PLANNING, ZONING, & BUILDING DEPARTMENT
PZ&B Staff Combination Memorandum: Architectural Commission and Town Council

SUBJECT: ARC-23-026 (ZON-23-034) 171 EL PUEBLO WAY (COMBO)

MEETING: MARCH 29, 2023 (ARCOM)
APRIL 04, 2023 (TC)

The applicant has submitted plans, entitled "PRESSLY-RYAN RESIDENCE" as prepared by **SKA Architect + Planner (Jacqueline Albarran)** dated February 9, 2023.

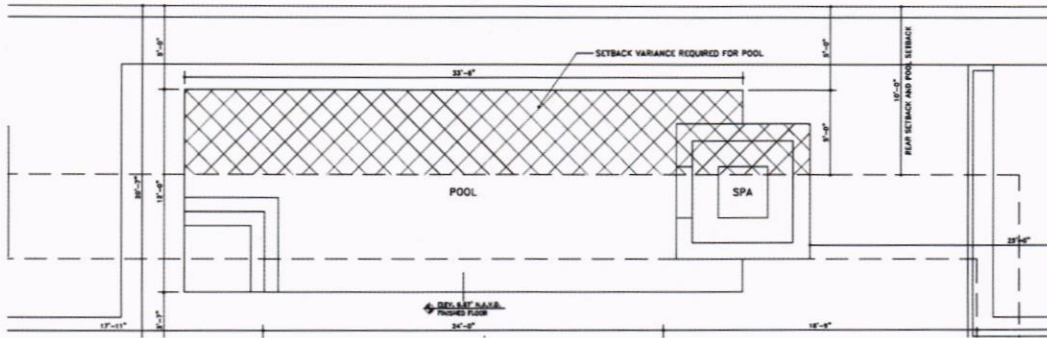
This application is presented to the Commission to consider whether all of the criteria in Sec. 18-205 have been met. A preliminary review of the project indicates that the application, as proposed, is inconsistent with the Town zoning code and requires three variances. The application proposes the construction of a new two-story single-family residence on a substandard size lot within the R-B Zoning District. Due to the lot's deficiencies in width and area, the application will require a Special Exception with Site Plan Review to be reviewed by Town Council.

The parcel has public frontage along El Pueblo Way and N Ocean Way. Proposed site design features include a two-story mass on El Pueblo Way with a single story wing and side loaded garage off the side of the structure on N Ocean Way. A walkway and garden connect El Pueblo Way with the South facing front door. The side-loaded garage and driveway are separated from the primary façade on the west side of the structure and parcel. The parcel is enclosed on two sides with a masonry wall and a black chain link fence. The site plan also features a rear covered loggia, pool with spa, a water feature, and raised terrace.

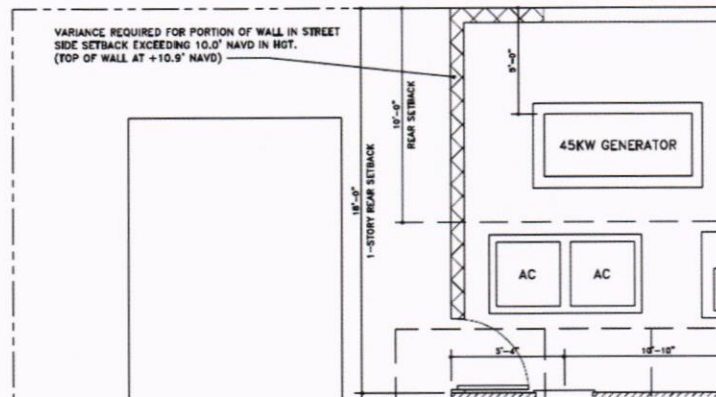
Code Section	Required	Proposed	Variance
Sec. 134-1667	A generator to be completely screened by a masonry wall not exceeding max wall height.	A generator screening wall which exceeds max wall height by 11" to completely screen the generator.	A wall height of 6' 11" in lieu of the 6' maximum permitted in a street side yard setback.

The existing site grade is lower than the required FEMA elevation, resulting in equipment required to be installed on stands or raised equipment pads. The zoning code requires that equipment be screened by a wall as high as the equipment, but not higher than allowed by code. In this instance, the applicant must install a screening wall which is less than 1' higher than allowed by code, so that the generator equipment will be completely screened from the street.

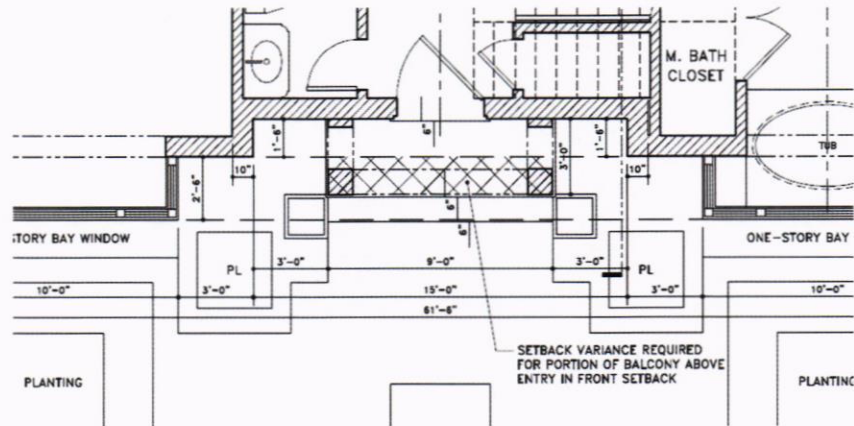
Code Section	Required	Proposed	Variance
Sec. 134-1093(b)(5)b	2 nd story balcony features must be located outside of the required 2 nd story setback.	A balcony feature which is located at a 23' setback in lieu of the 25' setback required.	2' second story front yard setback encroachment.

The applicant has reduced the front yard setback by increasing the rear yard setback, which is permitted by code. The applicant proposed an one story entry feature with a balcony. Because the balcony is considered a second story feature, it must meet the second story setback requirement. The applicant proposes for the entry to encroach 2' into the required 2nd story setback (but still

outside of the one story setback).
